Work Order ID 108605

Item Name: Crosstube Turning Detail

DART AEROSPACE LTD		Work Order: 108605
Description: Crosstube Assembly		Part Number: D407-667-245
Inspection Dwg: D407-667-245 Rev: F		Page 1 of 2

DRAWING NO. D407-667-245	TITLE CROSSTUBE ASSY (407 HIGH AFT)	REV. F	DART AEROSPACE LTD ENGINEERING ORDER		D.E.O. NO. D407-667-245-F-1	SHEET NO. SHEET 1 OF 2	SCALE NTS
DRAWN	CHECKED	MFG. APPR.	APPROVED	DE APPR.			
DATE 11.04.08	DATE 11.04.12	DATE 11.04.12	DATE 11.04.12	DATE 11.04.12

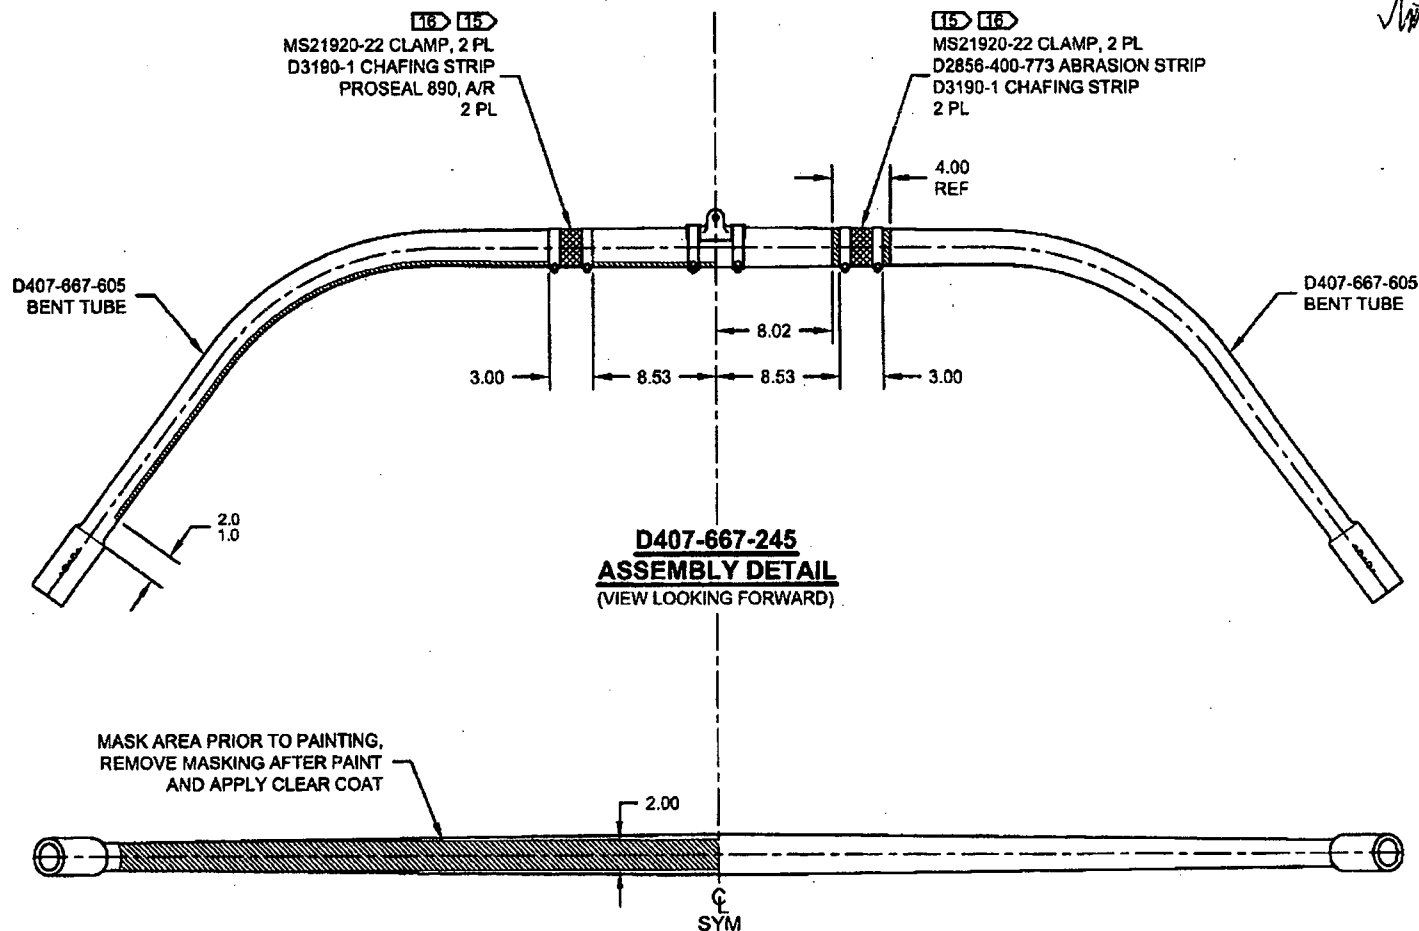
PURPOSE:

REMOVED ABRASION STRIP IN FAVOR OF A THIN LAYER OF PROSEAL 890.

NOTES 2 AND 15, SHEET 1 ARE AMENDED AS FOLLOWS:

- 2) FINISH: CHEMICAL CONVERSION COAT PER DART QSI 005 4.1
PRIME INSIDE AND OUTSIDE PER DART QSI 005 4.2
MASK UNDERSIDE OF CROSSTUBE AS SHOWN (HATCHED AREA) AND
PAINT OUTSIDE PER DART QSI 005 4.2
REMOVE MASKING AND APPLY CLEAR COAT
- 15) APPLY A THIN COAT OF PROSEAL 890 ON INSIDE CONCAVE SURFACE OF D3190-1
CHAFING SHIELDS AND LET CURE PER MANUFACTURER'S INSTRUCTIONS. INSTALL
PROSEALED D3190-1 CHAFING SHIELDS ONTO CROSSTUBE BY APPLYING A THIN COAT
OF PROSEAL 890 ONTO CROSSTUBE. BE SURE TO ELIMINATE ANY AIR GAPS.
